Project Address: 1050 E. Washington Avenue
Application Type: Other – Signs in an UDD, Comprehensive Design Review Amendment
Legistar File ID # [70520](#)
Prepared By: Jessica Vaughn, AICP, UDC Secretary
 Matt Tucker, Building Inspection Director

Project Description: The applicant is seeking Final Approval of a Comprehensive Design Review [signage] amendment to allow for additional signable areas above the first floor and for approval of a specific wall sign in Urban Design District No 8.

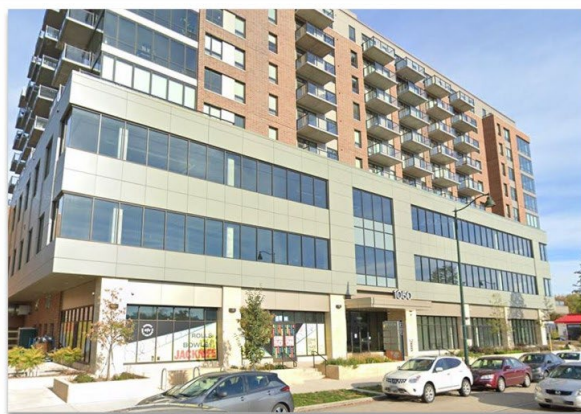
Staff Analysis: Staff has concerns with the shift in sign type as it relates to consistency with both UDD 8 design guidelines and CDR review criteria. While the proposed sign type is among the preferred sign types in UDD 8, original approvals only anticipated wall signage for ground floor tenant spaces. As shown in the Final Approval plans above, projecting signage was anticipated for upper story tenant spaces, in two locations within vertical elements, which resulted in an overall clean, simple building façade and articulation within the building’s vertical elements. As proposed, the wall signage for upper story tenants would increase the overall amount of signage on the building’s front façade. In conjunction with the ground floor tenant spaces, this would result in visual clutter along the building’s street facing façade. In addition, a shift in practice to allow for wall signs as requested may result in similar requests at other properties in the corridor, which currently do not have wall signs above the second story. In at least one case, such an allowance would be a reversal of the UDC’s decision for signage approval (The Constellation).

Similarly, with regard to sign locations or signable areas, the building design does not lend itself to clearly identifiable sign areas other than the three vertical elements on the elevations, two of which were anticipated to host signage. As shown in the Final Approval elevations, the projecting signs were proportional to and centered within the two identifiable sign areas. While the proposed wall signs could certainly be centered within the proposed sign areas noted in the application materials, they are not proportional to the horizontal building element in which they would be mounted.

Overall, staff is not supportive of the shift in sign type. Maintaining the projecting sign type would not only be consistent with original approvals, but also limit sign clutter, potentially improve sign visibility, and also maintain the overall building design aesthetic.
